UCI Mesa Court Expansion Structural Submittal

GFRC Panels and Connections

SUBMITTED: 12/24/2014 RESPONSE DUE: 1/14/2015 Note: See sheet PC8.1 for detai change per RFI 1334. MRD 1.25.2014

DCI ENGINEERS

PC1.1

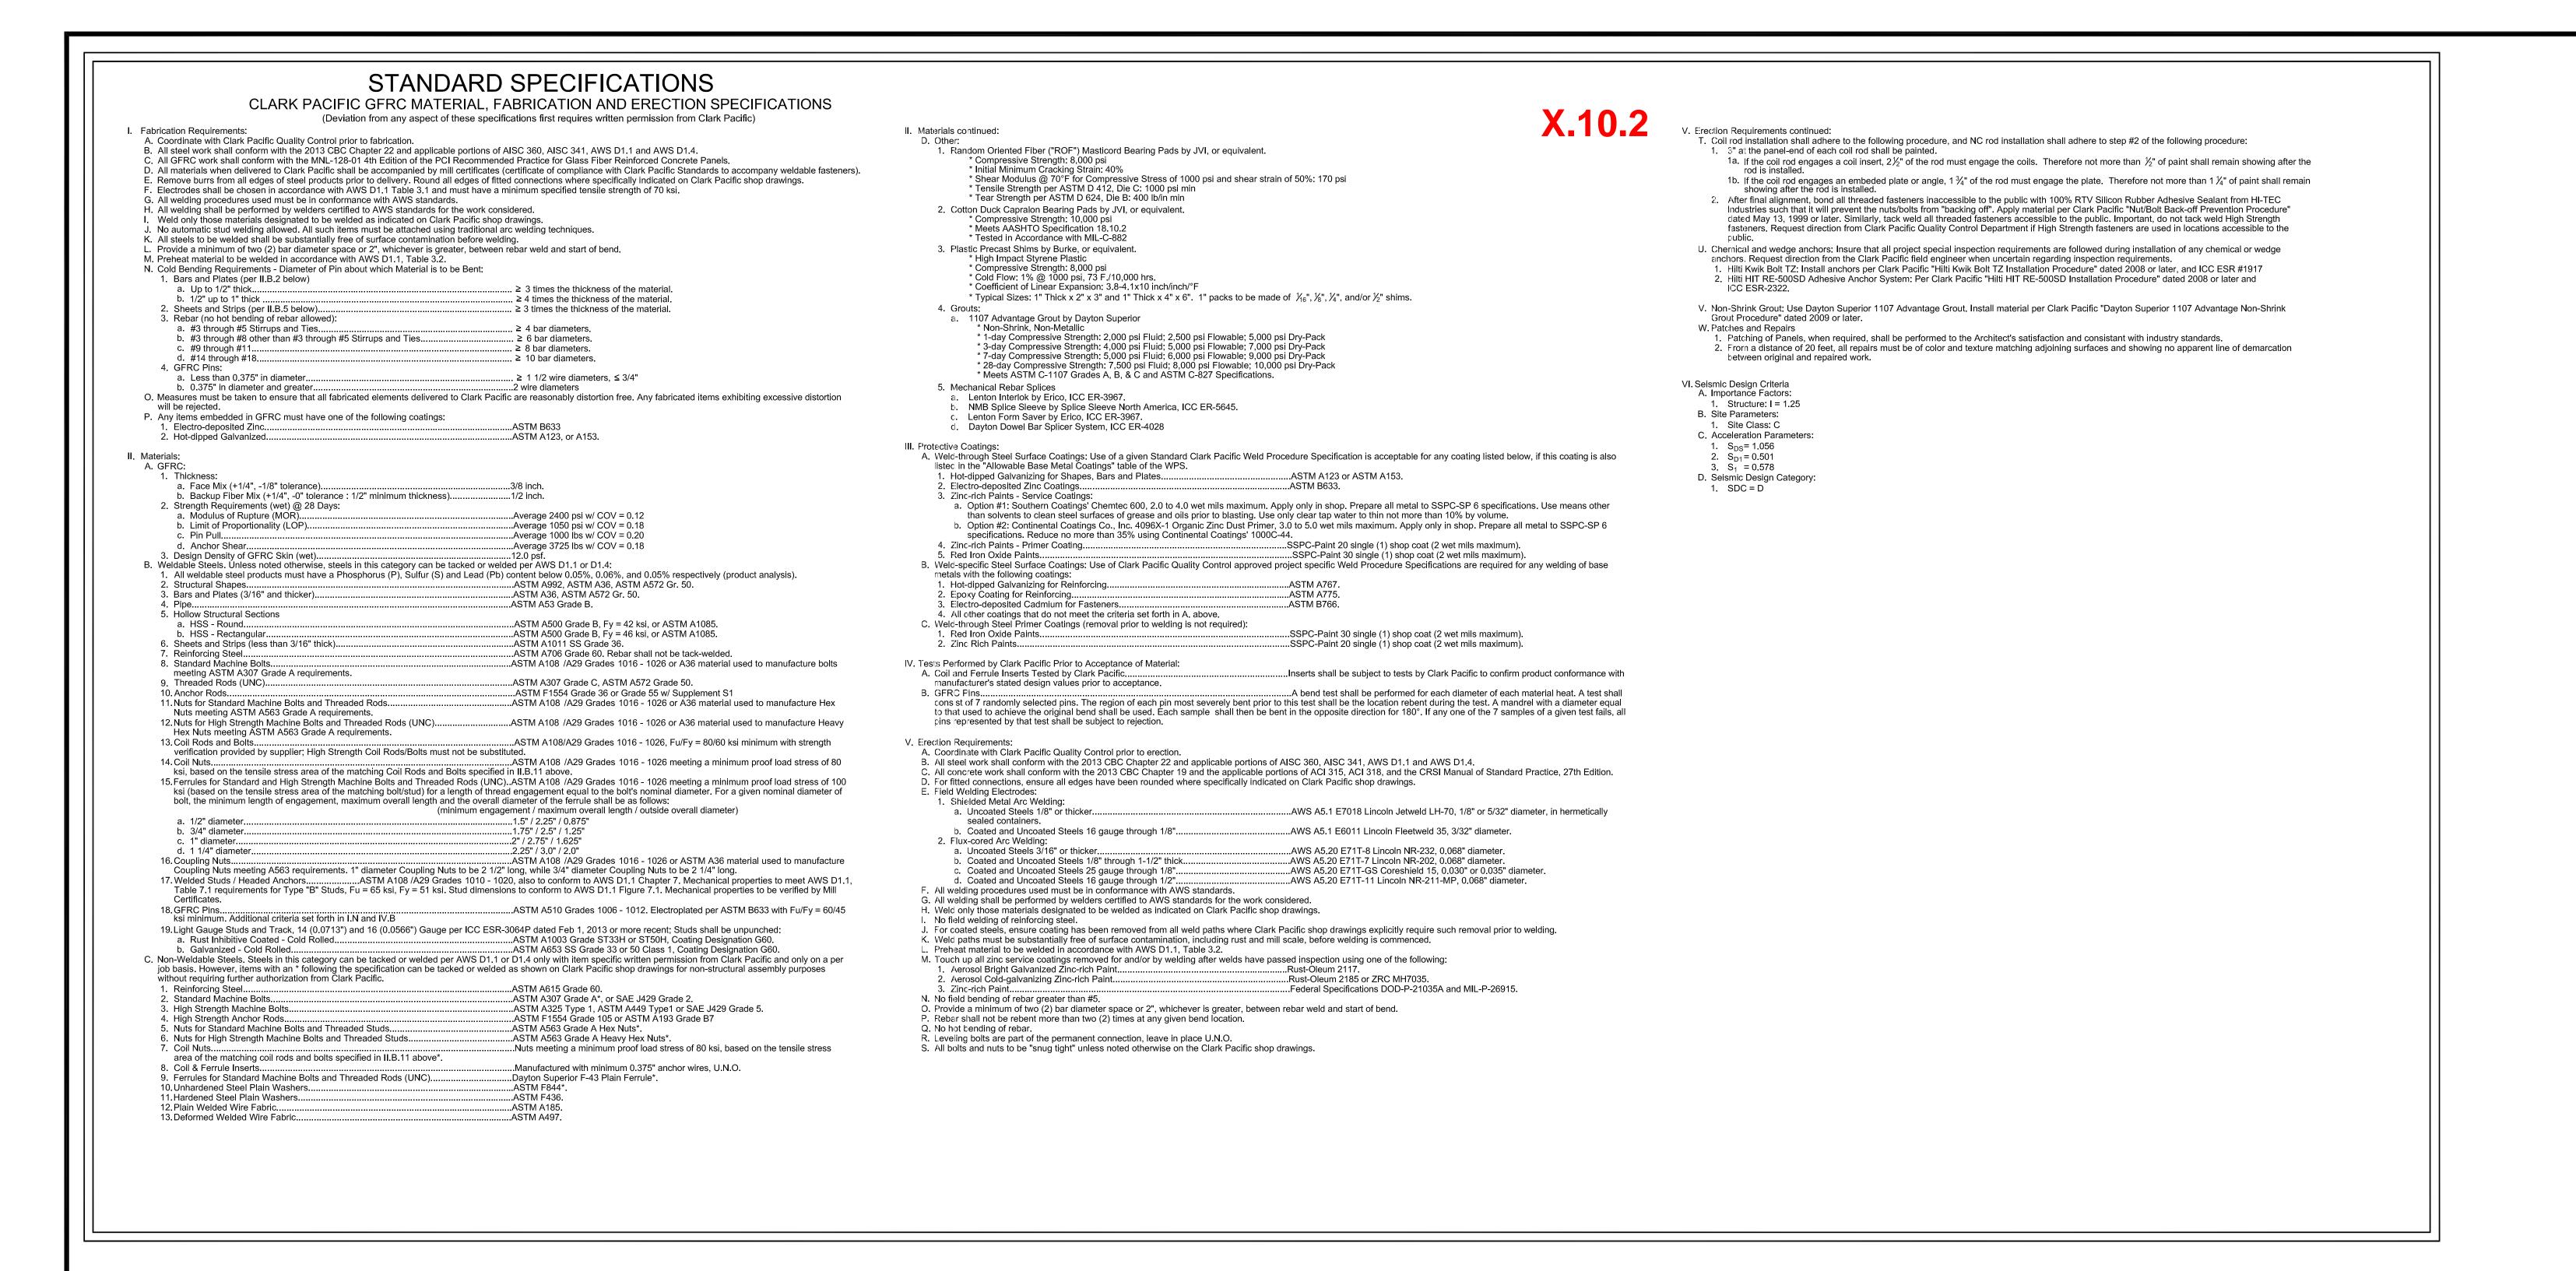
VERIFY ALL DIMENSIONS WITH ARCH.

SUBMITTAL REVIEWED FOR COMPLIANCE OF PANEL CONNECTIONS TO EMBEDS ONLY. PROVIDE CALCULATIONS AND SHOP DRAWINGS FOR PANEL FRAME MEMBERS FOR FUTURE REVIEW.
